# UNITED STATES PATENT AND TRADEMARK OFFICE

APPLICATION NO.	FILING DATE	FIRST NAMED INVENTOR	ATTORNEY DOCKET NO.	CONFIRMATION NO.
10/786,933	02/25/2004	Toshinobu Homan	4041J-000844	5063

**Office Action Summary**

**Figure 1 Iwanami et al.**

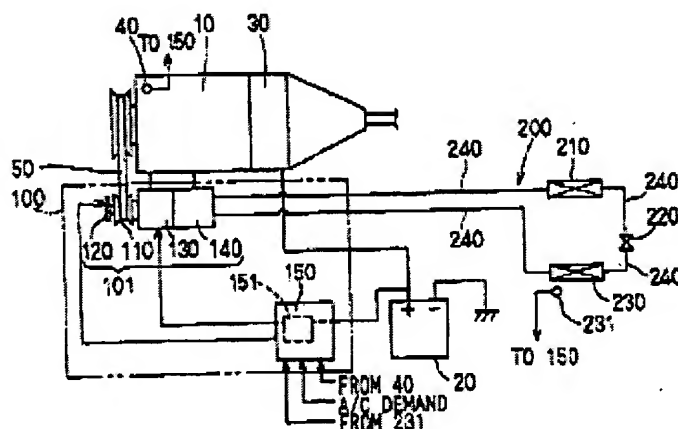
Regarding claim 1, Iwanami et al. teaches compressor control system capable of being used for an air conditioner of a vehicle (Figure 1).

Iwanami further teaches a hybrid vehicle with a driving electric motor 30 (column 6 lines 10-20), a main battery 20 capable of supplying electric power to the motor (column 7 lines 10-20). In addition, Iwanami discloses a compressor 140, in a refrigerant cycle 200 of the vehicle air conditioning system, with a motor 130 (column 2

lines 34-53). The motor includes a control means 150, which controls its rotation speed (column 4 lines 10-17).

Iwanami et al. fails to teach a driving electronic control unit with a function for controlling a drive power switching of the vehicle. Tamegai (US 6287081) discloses a control apparatus for a hybrid compressor with a control unit 22 capable of switching the vehicle between the driving engine and driving motor mode (column 2 lines 6-16). It would have been obvious to one of ordinary skill in the art at the time of the invention to modify Iwanami with Tamegai in order to provide the ability to switch from the driving engine to the driving motor modes of operation, thus taking advantage of the economic benefit of the driving engine and the efficiency benefits of the driving motor.

Figure 2 Takahashi et al.

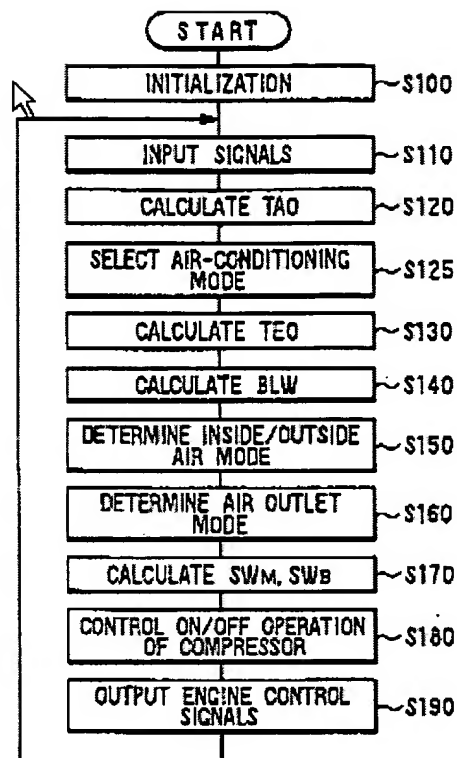
Regarding claims 2 and 3, Iwanami in view of Tamegai fails to teach an air conditioning unit and a driving electronic control unit in communication with one another. Takahashi discloses a vehicle air conditioning system with an air-conditioning electronic control unit (A/C ECU) 5, which controls operation of the air conditioner based on an air conditioning signal input (column 13 lines 37-66). Takahashi further teaches the air conditioning electronic control unit can communicate with a driving electronic control unit of the system (column 14 lines 1-5). Takahashi further discloses the air conditioning ECU 5 and vehicle ECU 38 can communicate with one another through a local area network made up of microcomputers each of which has a CPU, ROM, RAM and additional peripheral circuits (column 14 lines 30-46). It would have been obvious to one of ordinary skill in the art at the time of the invention to modify Iwanami in view of Tamegai with Takahashi in order to enable the air conditioning system (A/C ECU) to function separately from the system that drives the vehicle (ECU). This prevents problems that occur with vehicles that have a single (ECU) to operate both the air conditioner and the vehicle. An example of this is when a vehicle engine drives the compressor of the air conditioning system and there is an increase in temperature of the passenger compartment of the vehicle due to a vehicle stoppage.

In regard to claim 4, Takahashi teaches an air-conditioning electronic control unit 5 capable of calculating a target air temperature and blowing amount of conditioned air blown into a vehicle passenger compartment (column 14 lines 58-66 and column 16 lines 10-20 and Figure 2).
